**CPED STAFF REPORT**  
 Prepared for the City Planning Commission

CPC Agenda Item #6  
 April 7, 2014  
 BZZ-6467

*Property Location:* 708 Central Avenue NE and 119 - 123 7<sup>th</sup> Street SE  
*Project Name:* 700 Central  
*Prepared By:* [Becca Farrar-Hughes](#), Senior City Planner, (612) 673-3594  
*Applicant:* 7<sup>th</sup> & Central, LLC, (952) 767-2502  
*Project Contact:* Nolan Properties Group, LLC  
*Request:* To allow a new mixed-use development with a total of 156 dwelling units (179 bedrooms) and up to 10,000 square feet of ground level commercial space.

1 Site Plan  
1" = 20'-0"

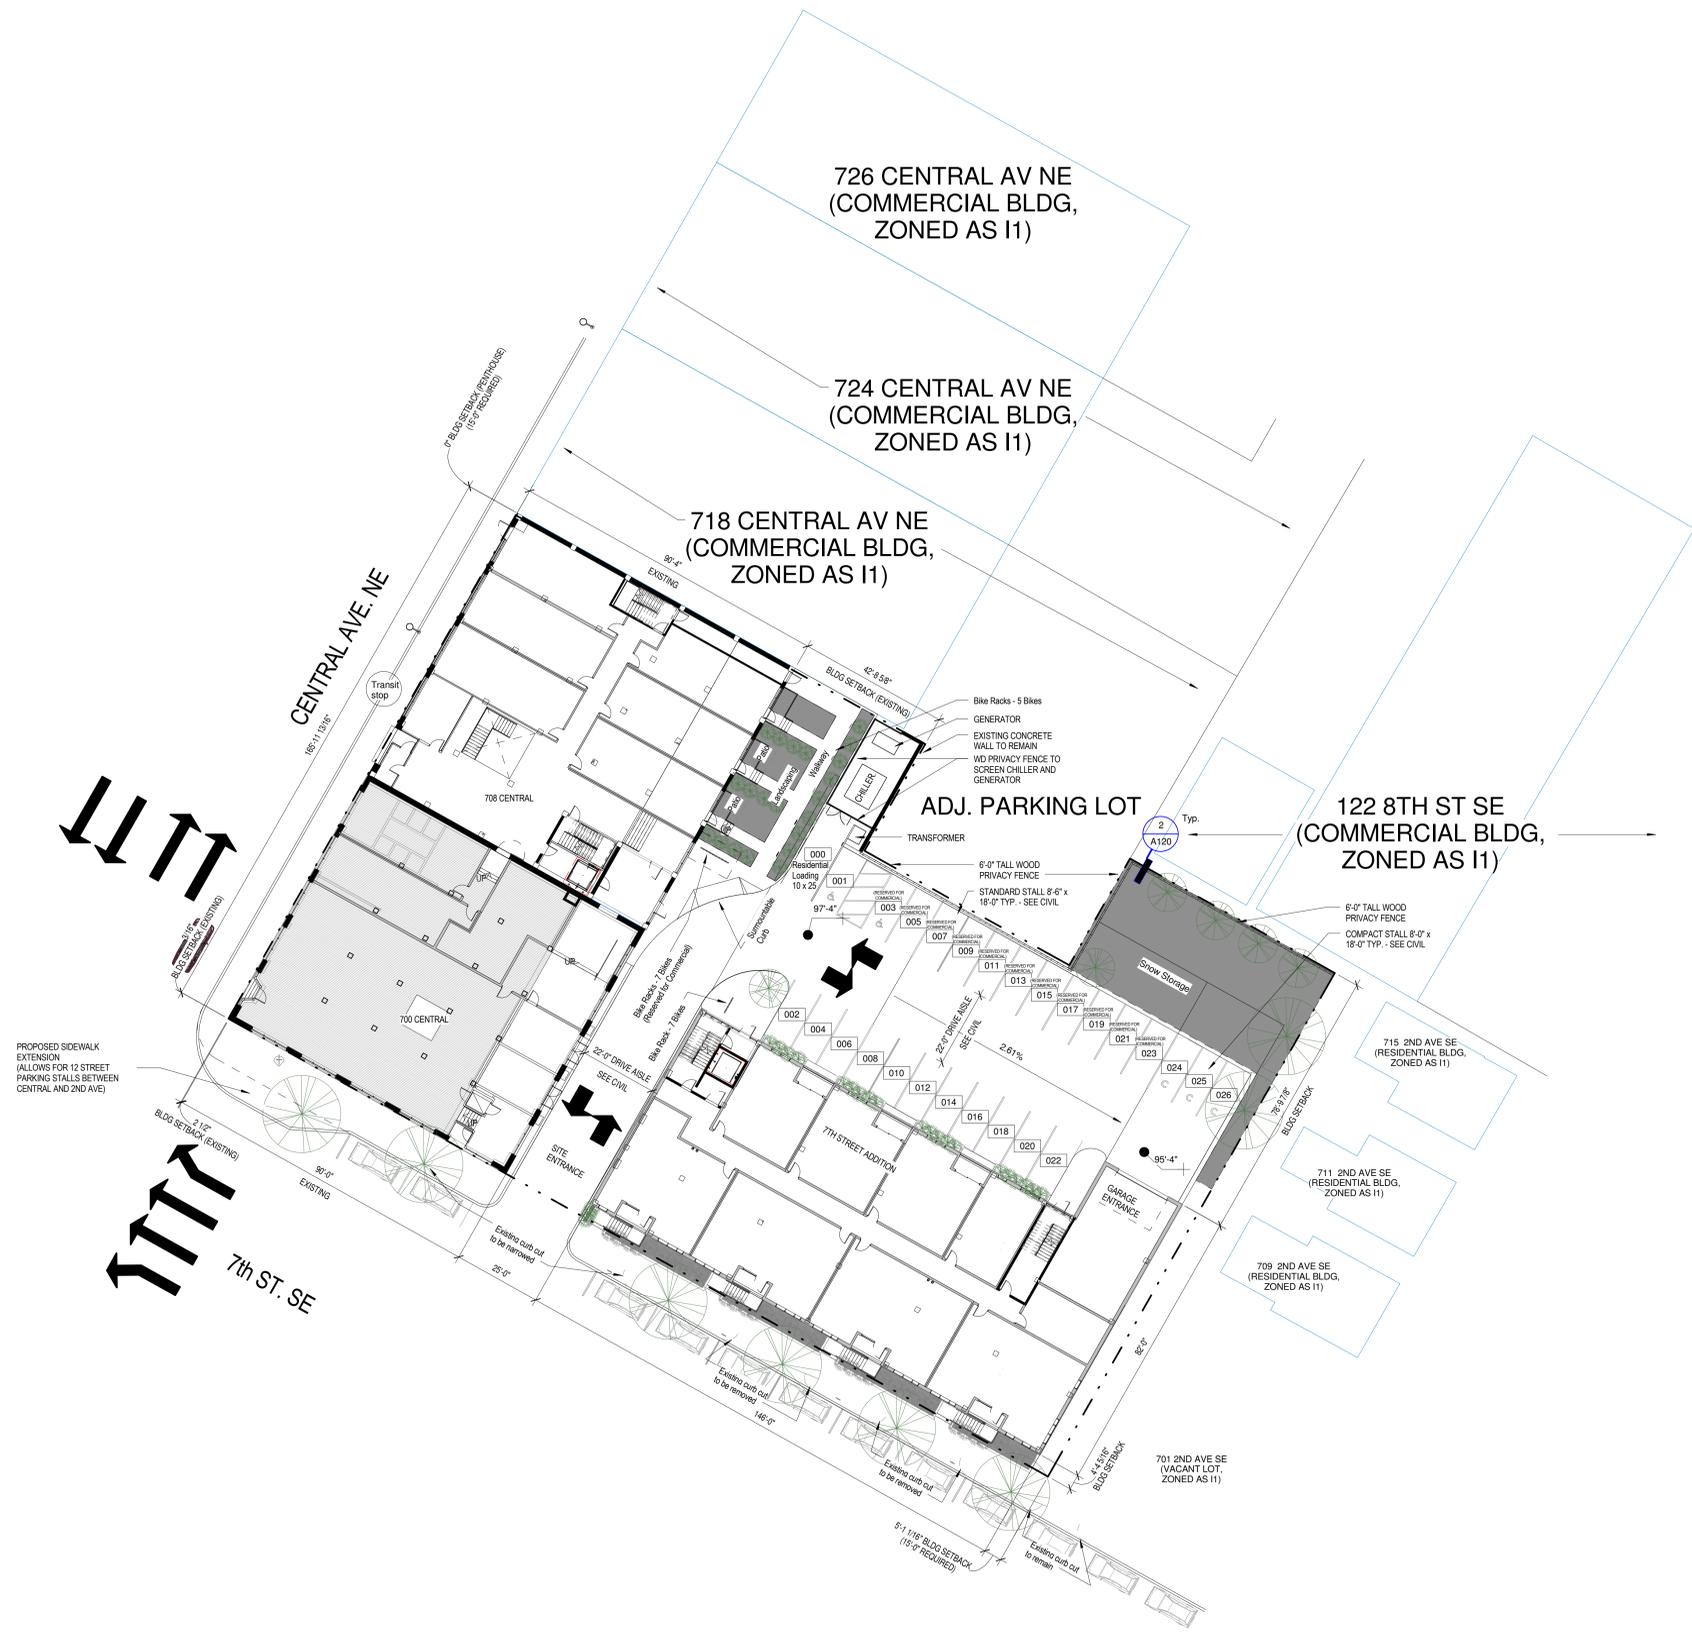
- A well-lit walkway at least 4 feet in width does not connect the buildings and the adjacent public sidewalks to the on-site parking. Alternative compliance is necessary. Staff would recommend that the Planning Commission require that the applicant provide a minimum of a 4-foot wide walkway to connect the on-site parking lot to the sidewalk along 7<sup>th</sup> Street SE.

- The bump-out and parking bay shown along 7th St. S.E shall be designed to provide a 3:1 taper starting 20' from the end of the curb radius. Striping for parking spaces shall be removed from all plan sheets; as this is a responsibility of the Traffic Department.

Landscape  
Planting Plan  
**L1**

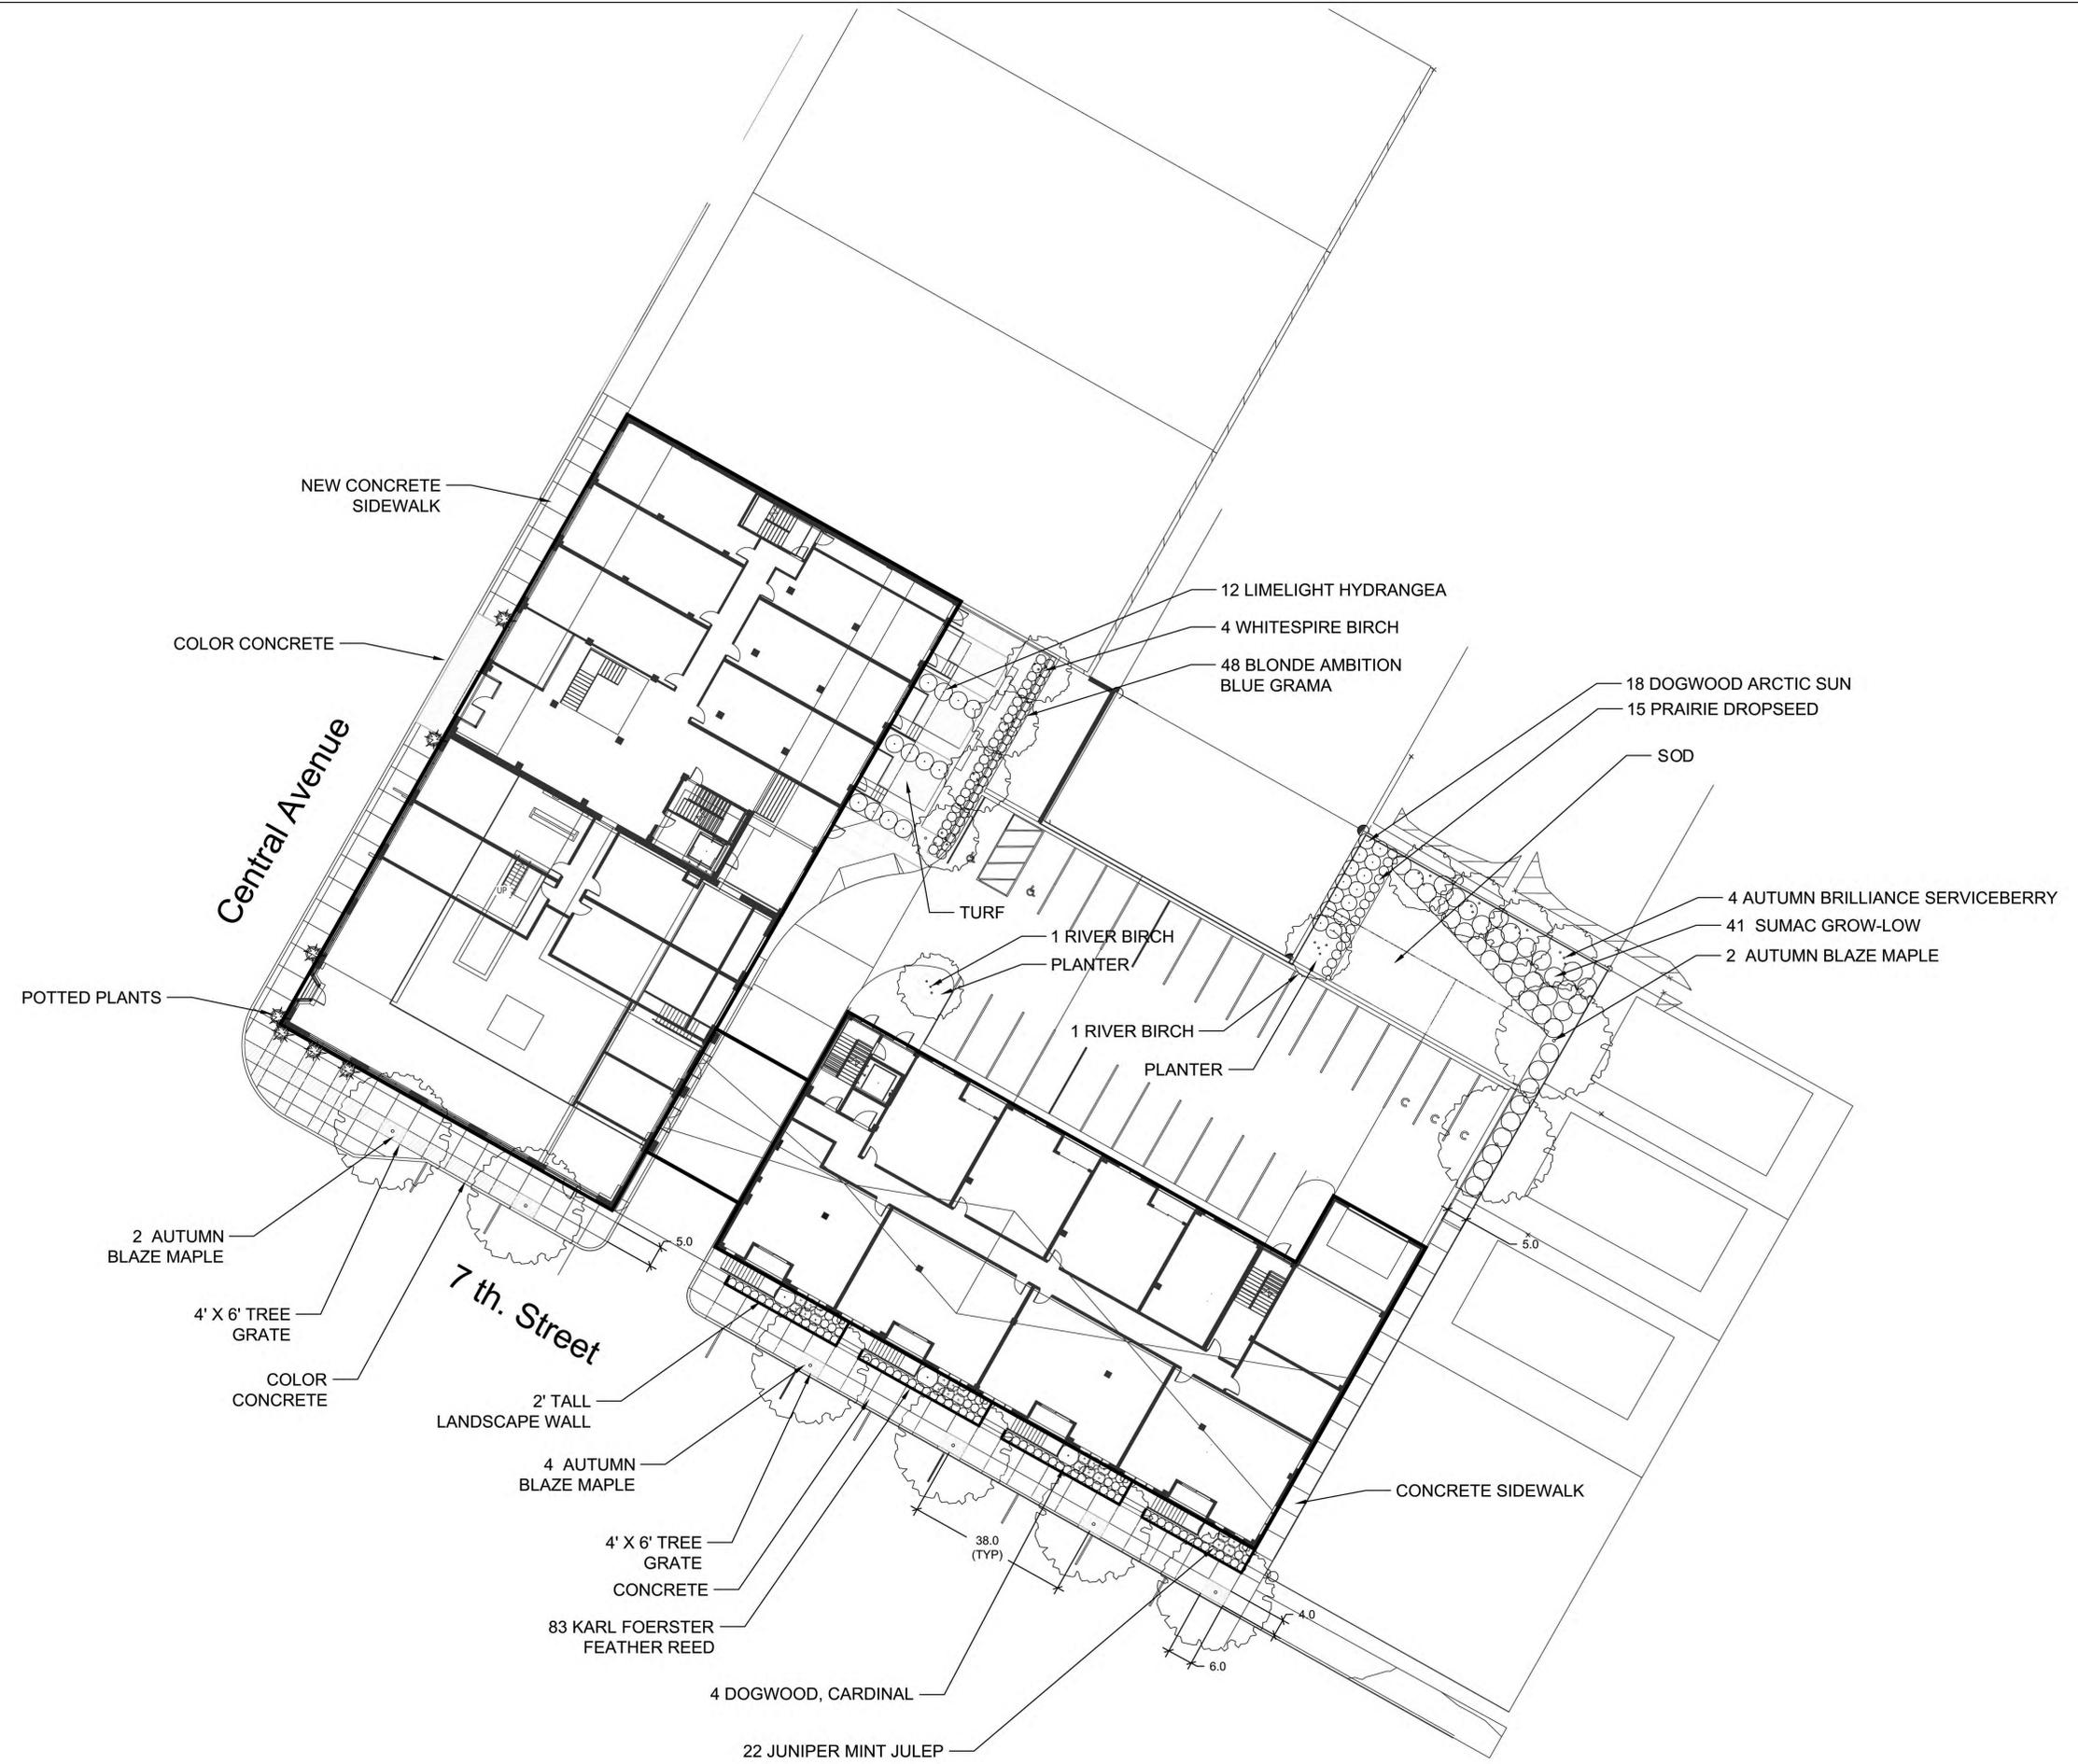
- The ADA pedestrian ramp at the corner shall be oriented to direct pedestrians to cross 7th St SE.
- The public sidewalk shall be constructed such that an unobstructed minimum of 6' wide is provided throughout the pedestrian zone (the Landscaping Plan Sheet L1 indicates a 5' wide sidewalk).
